**SOLICITATION AMENDMENT
MODIFICATION DE L'INVITATION**

Title - Sujet Docking CCGS Edward Cornwallis		
Solicitation No. - N° de l'invitation F5561-150333/A		Amendment No. - N° modif. 003
Client Reference No. - N° de référence du client F5561-15-0333		Date 2015-07-06
GETS Reference No. - N° de référence de SEAG PW-\$HAL-302-9550		
File No. - N° de dossier HAL-5-75032 (302)	CCC No./N° CCC - FMS No./N° VME	
Solicitation Closes - L'invitation prend fin at - à 02:00 PM on - le 2015-07-14		Time Zone Fuseau horaire Atlantic Daylight Saving Time ADT
F.O.B. - F.A.B. Plant-Usine: <input type="checkbox"/> Destination: <input checked="" type="checkbox"/> Other-Autre: <input type="checkbox"/>		
Address Enquiries to: - Adresser toutes questions à: Gaudreau, Michel		Buyer Id - Id de l'acheteur hal302
Telephone No. - N° de téléphone (902) 496-5245 ()		FAX No. - N° de FAX (902) 496-5016
Destination - of Goods, Services, and Construction: Destination - des biens, services et construction:

Solicitation Amendment No 003 is issued for the following purposes:

Solicitation F5561-150333

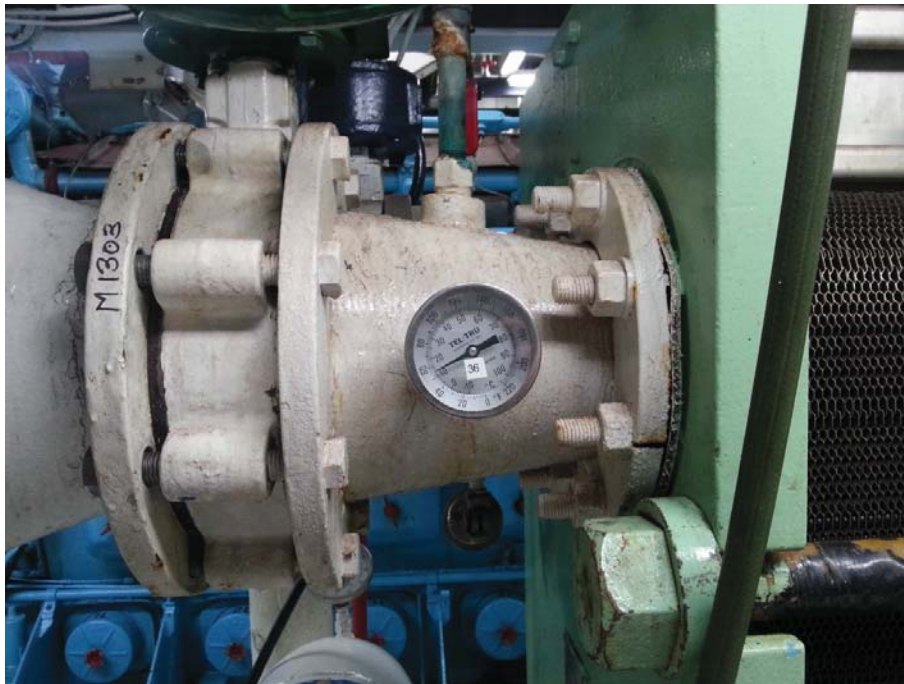
Question 8:

HD-15 – Seawater outlet piping from coolers: Please specify length, spool diameter to be replaced, fittings required, etc... Please attach pictures, drawings or associated information that would provide some information on this specification item.

The spool length is approximately 9 inches from flange to flange. It reduces from 8 inch to 6 inch, and has a ¾ in NPT gauge connection and a ½ in NPT vent connection. The following pictures are provided for guidance:

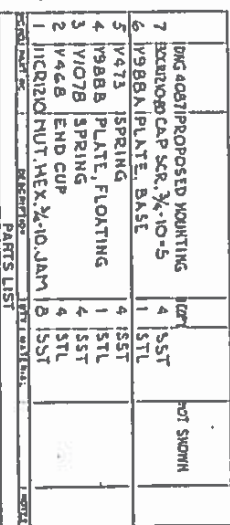
Question 17:

L-04 A-Frame Searchlight. Please provide drawing # 7225?

The drawing is included on the following page.
